TO: Phil Waterman  
FROM: Phil Anderson  
DATE: March 19, 1975  
SUBJECT: 1019 Game

INSTRUCTIONS FOR 1019 REEL DISC CARD CHANGE

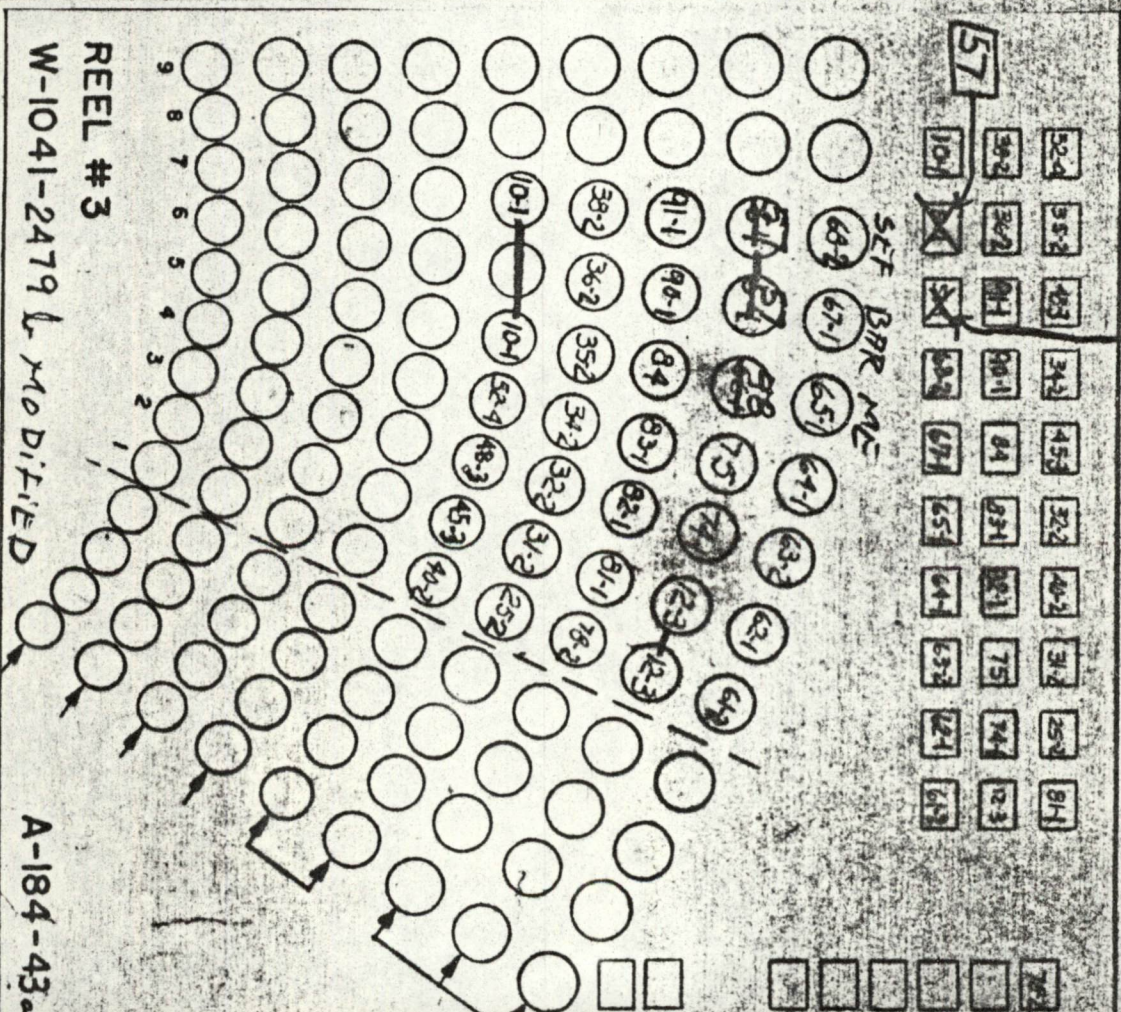
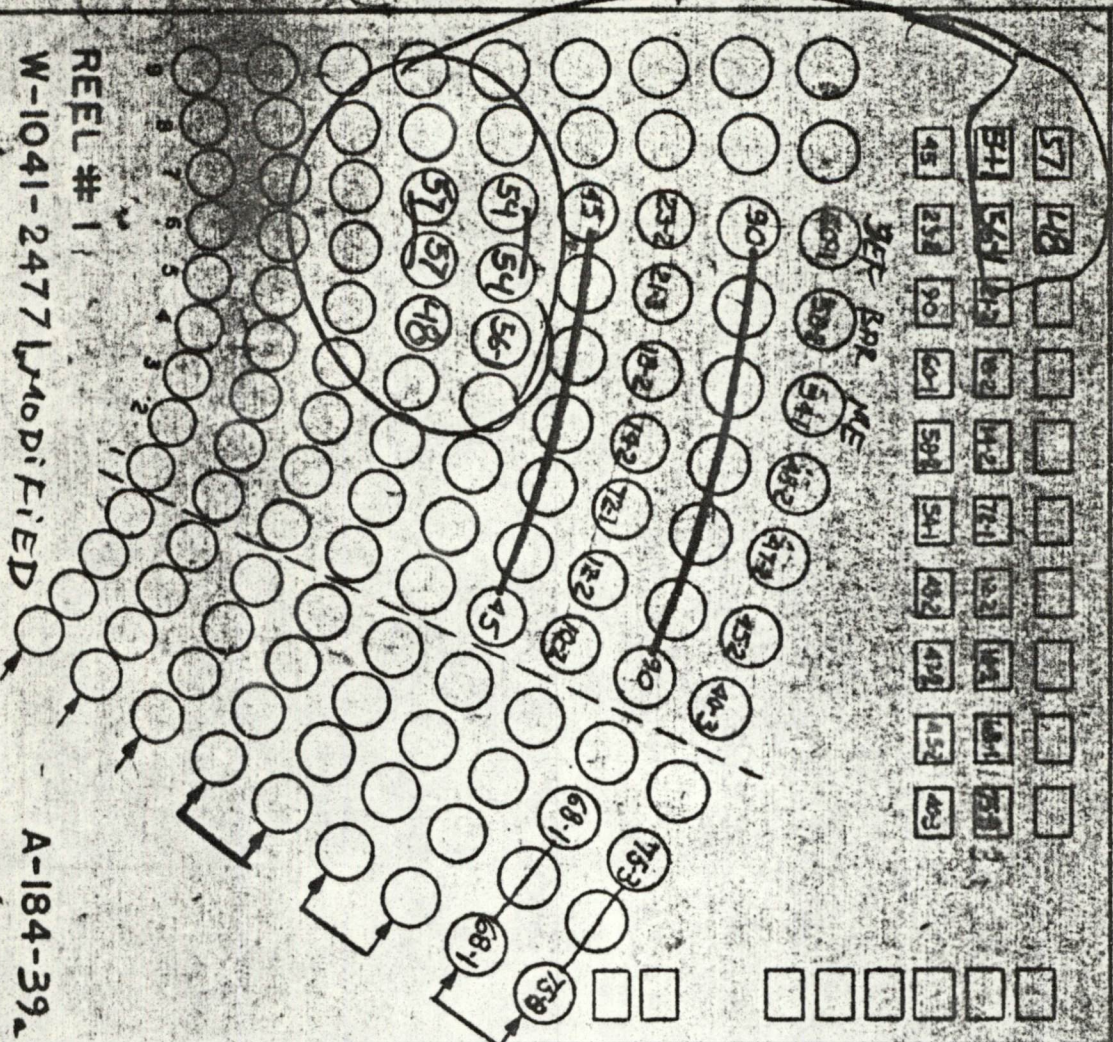
You will soon be receiving Game #1019 (so called Wheeler Dealer). Geoge Hubbard discovered a loop circuit in the payout system but he was too late to get all games changed. Enclosed you will find a drawing plus step by step instructions to make this change, please be sure to check out all of the machines.

- 1) Add jumpers on reel disc #1 as shown on W 1041-2477 modified.
- 2) Remove wires 54 and 56-1 from reel card #3 and route them to reel card #1 (they are too short and will need to be spliced).
- 3) Solder wires 54 and 56-1 to added terminals on reel card #1.
- 4) Solder two (2) wires, numbers 57 and 48 to reel card #1 as shown on W 1041-2477 modified.
- 5) Route wires 57 and 48 from reel card #1 to reel card #3, solder as shown on W 1041-2479 modified.
